# Customer Service Notice

Date: August 30, 2011

Units Affected: All utility service bodies in service between May 1, 2009 and June 1, 2011

## Body Door Latch Inspection

*Figure 1 — Primary Latch Position*

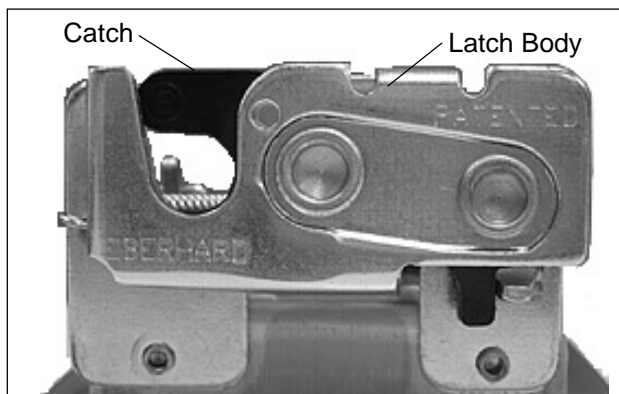
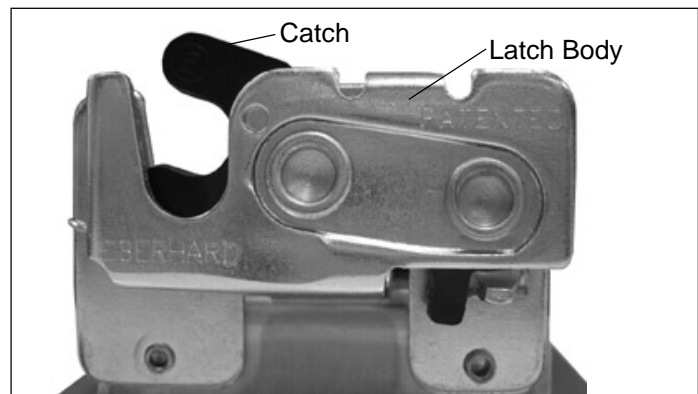
When placed into the primary position (refer to Figure 1), the door is considered fully secured. When the door is not fully closed, the latch is in the secondary position (refer to Figure 2). Supplier investigation identified potential deficiencies in the secondary latching mechanism of some supplied latches. Such parts may not fully retain the compartment door during travel if the latch is in the secondary position. **Death or serious injury can result from items falling from a moving vehicle. Open body compartment doors can allow items to fall from a moving vehicle.**

Altec requires all latches on affected units to be inspected in secondary latching position to make sure they are functioning properly. This inspection must be done on or before the next scheduled periodic maintenance (not to exceed six months of receiving this CSN). If a latch is found to be defective, the unit and vehicle can remain in use, but the latch must be replaced at the next scheduled periodic maintenance (not to exceed six months from date of inspection). The operator must be sure the door is completely closed and latched in the **primary** latch position before transport. The inspection, and any needed latch replacement, can be done by the customer.

**Figure 3 — Testing The Latch**

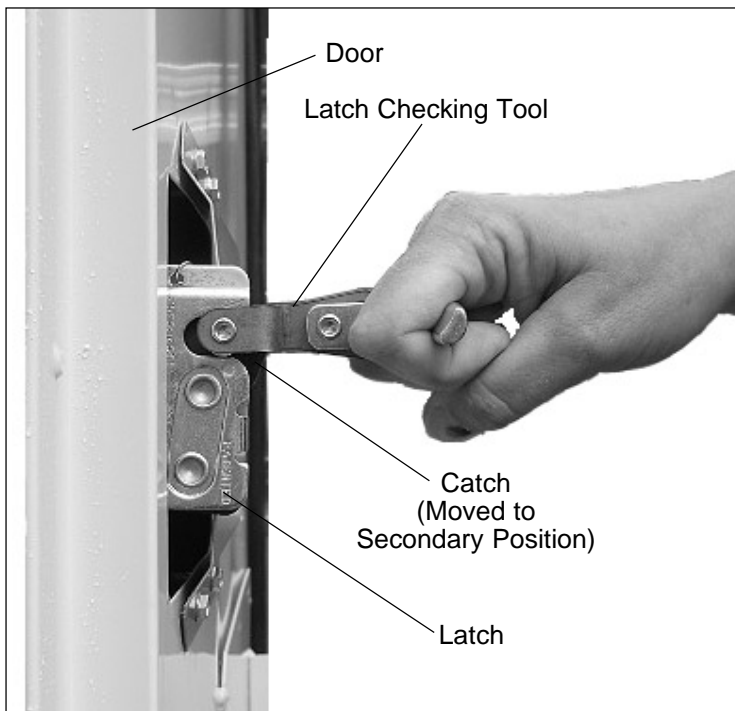
3. With your feet positioned to ensure good balance, place your hand on the edge of door. Use your other hand to pull outward or upward on the checking tool (refer to Figure 3) using a strong, steady pull. Do not jerk on the checking tool handle to test the latch. Applying a strong, steady pull on the tool should not release the latch in the secondary position.

4. If the catch releases, replace the latch no later than the next scheduled periodic maintenance (not to exceed 6 months).
